Subject: MHI's Revised Response to US-APWR DCD RAI No. 861-6062 Revision 3 (SRP 15.06.05) Question No. 15.6.5-100

MHI's Revised Response to US-APWR DCD RAI No. 861-6062
Revision 3, Question No. 15.6.5-100

RAI NO.: **NO. 861-6062 REVISION 3**

SRP SECTION: **15.06.05 – LOSS OF COOLANT ACCIDENTS RESULTING FROM SPECTRUM OF POSTULATED PIPING BREAKS WITHIN THE REACTOR COOLANT PRESSURE BOUNDARY**

Fig. 1-1 Expected Mixing Flow in the US-APWR

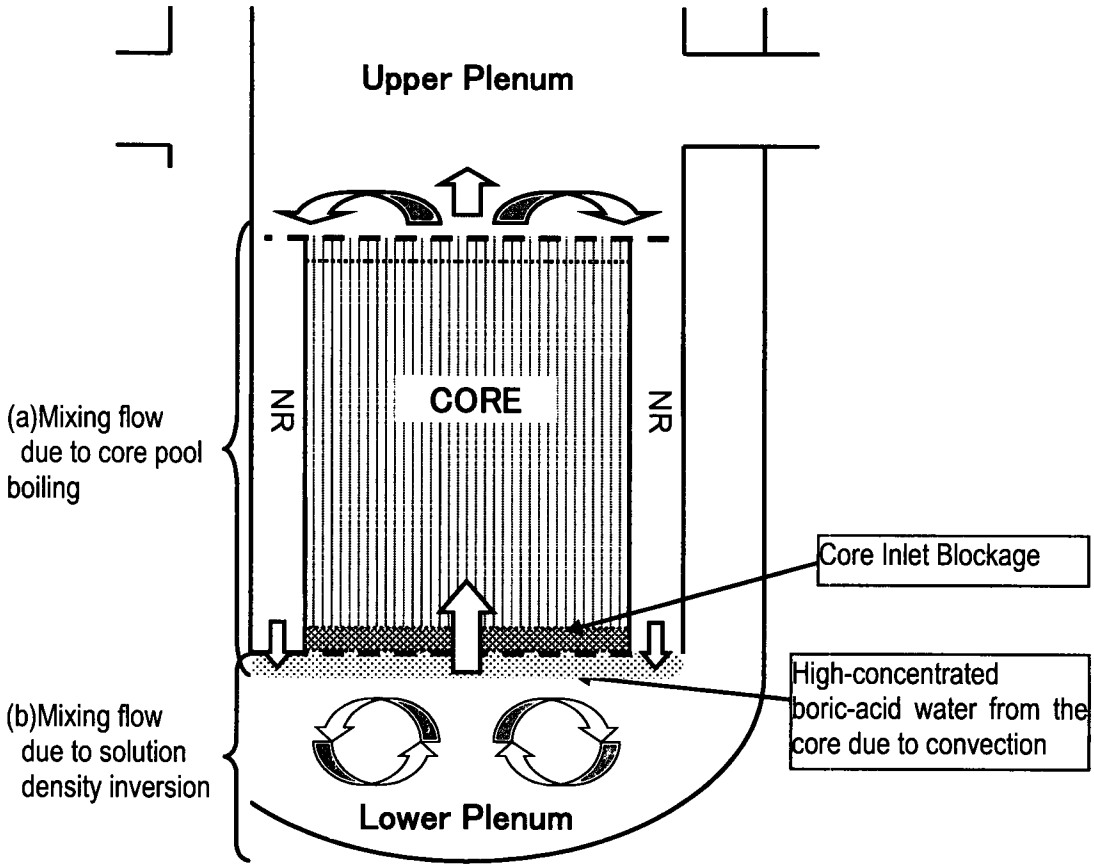
Follow-up to RAI 5352, Question 15.6.5-89:
Provide an updated response to RAI 719-5352, Question 15.6.5-89 that takes into consideration relevant and conforming findings related to US-APWR core debris blockage that also accounts for any experimental test results to assess the US-APWR core blockage. Currently, such additional information is planned to be included in Revision 2 of MUAP-080013-P, "US-APWR Sump Strainer Downstream Effects," scheduled for release by MHI on August 31, 2011.

MHI assumes that condensed boric acid water generated in the core is carried to under the lower core support plate through the core outer channel and NR channel even under core inlet blockage conditions. To confirm the aforementioned flow pattern, MHI performed the WCOBRA/TRAC (M1.0) code based large break LOCA long-term core cooling analysis to demonstrate that the NR is an alternate flow path between the core and lower plenum and to confirm the flow direction and flow rate of the NR region.

(a) NR downward flow appears during the post-LOCA long-term period
(b) Mixing flow due to unstable density difference has been shown by the BACCHUS test results.
